(ST1912) **Georgetown Apartments**, Easttown Dr., received revised site plan approval in 2017 (ST1709) for apartments, including six 12 unit buildings, two 10 unit buildings and twelve 16 unit buildings, for a total of 284 units for a density of 11 units per acre, which are allowed by right under Sec. 11.2(C), in the (HDR) High Density Residential district, located between Chicago Dr. and VanBuren, at Easttown Dr., P.P. # 70-14-28-400-058. Note that the ten single individual lots along VanBuren have been excluded from the review since they already exist and are already developed with houses.

ID number	ST1912	Date 6/21/2019	
Name	Georgetown Apartments		
Address	East Town Drive		
Use	apartments	SUP required	No. Allowed with Sec.11.2(C)

Proposed 2019 Plan

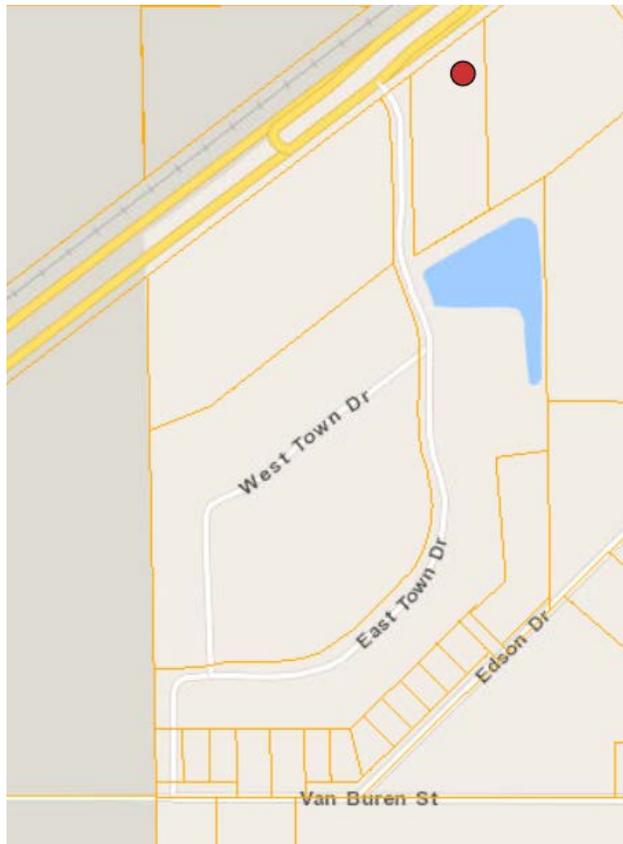
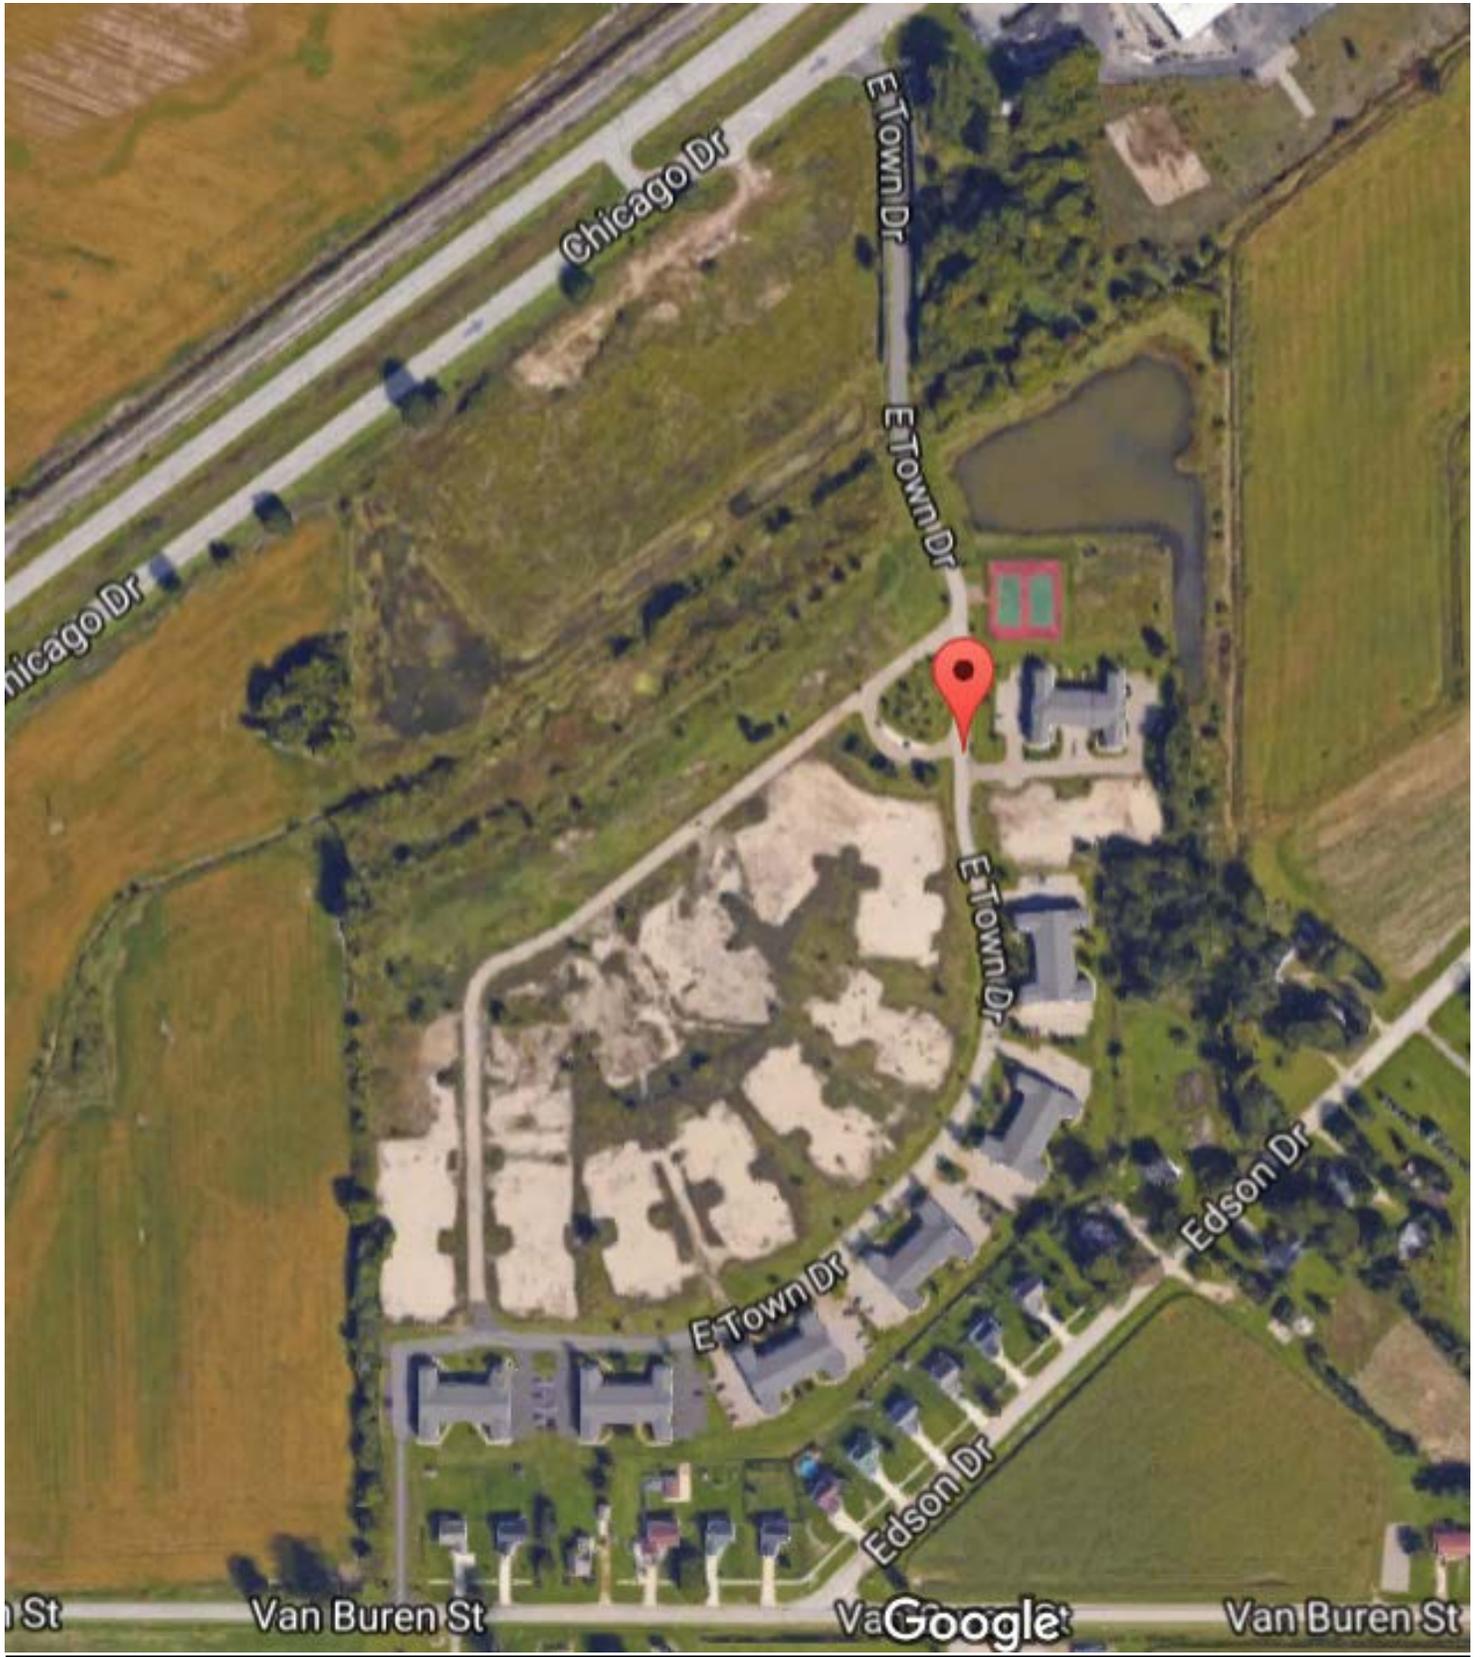
Buildings 1 & 2 combined

Two buildings combined into 1, the number of units to remain the same

The site plan for (ST1912) Georgetown Apartments, Eastown Dr., is approved for apartments, including six 12 unit buildings, two 10 unit buildings, ten 16 unit buildings (revised from twelve) and one 32 unit building (buildings 1 and 2 combined), for a total of 284 units for a density of 11 units per acre, which are allowed by right under Sec. 11.2(C), in the (HDR) High Density Residential district, located between Chicago Dr. and VanBuren, at Easttown Dr., P.P. # 70-14-28-400-058, as shown on the plan dated 5/29/19, based on the findings that all applicable standards of the ordinance have been met and the finding that the additional spaces are needed as per the email dated August 10, 2017 and with the following conditions:

MASTER PLAN

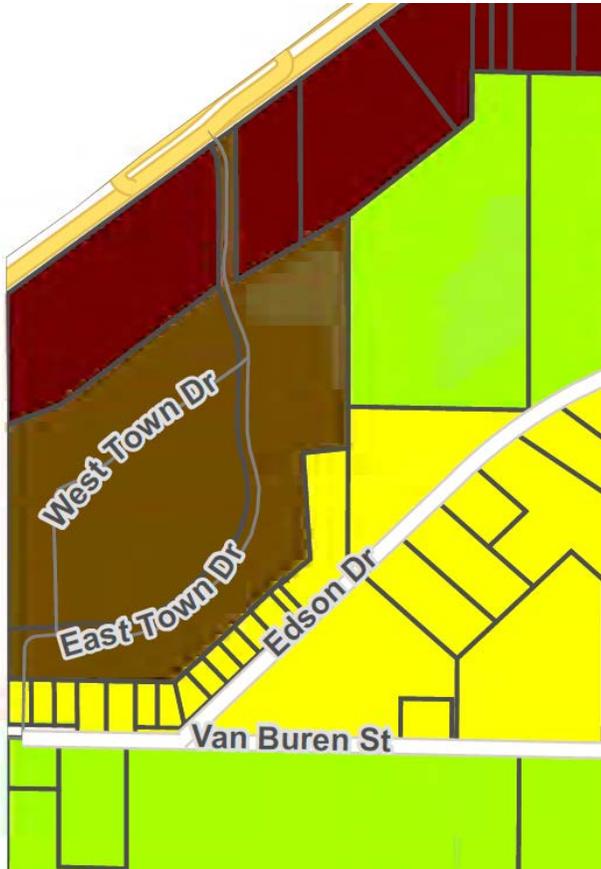
The proposal appears to be consistent with the Master Plan in regard to the uses and the density. The Future Land Use Map (adopted November 23, 2015) shows the area as HDR and the proposed density is noted to be 11 units per acre, which is less than the allowed 15 units per acre.
